VALIDATION & VERIFICATION REPORT

RISCALES REDD+ PROJECT

Document Prepared by AENOR CONFIA S.A.U.

Project Title	Riscales REDD+ Project
Report Title	Validation & Verification Report Riscales REDD+ Project
Version	3
Report ID	19112023_Val_Ver_Report_Riscales_REDD_Project
Verification Period	01-04-2014 to 31-12-2020
Client	FONDO ACCIÓN ICCO COOPERACIÓN
Pages	123
Date of Issue	12-05-2025
Prepared By	AENOR CONFIA S.A.U.
Contact	Génova 6. 28004 Madrid- Spain.

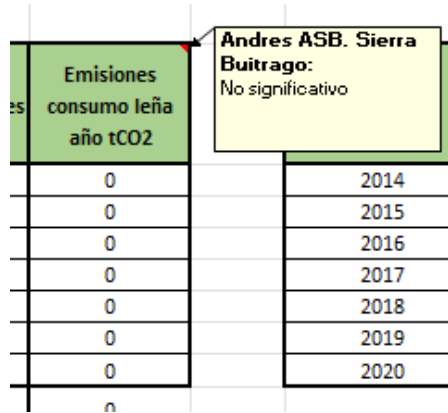
It should be clarified that the "4_Transiciones_RRD_2002-2014_LB", shows historical changes ex ante. And "11_Trans_LK_Expovts_2014-2020", are the variations of relative changes detected for the monitoring period, therefore, these proportions will not be the same. But it is clear if they are identified and weighted to the project area.
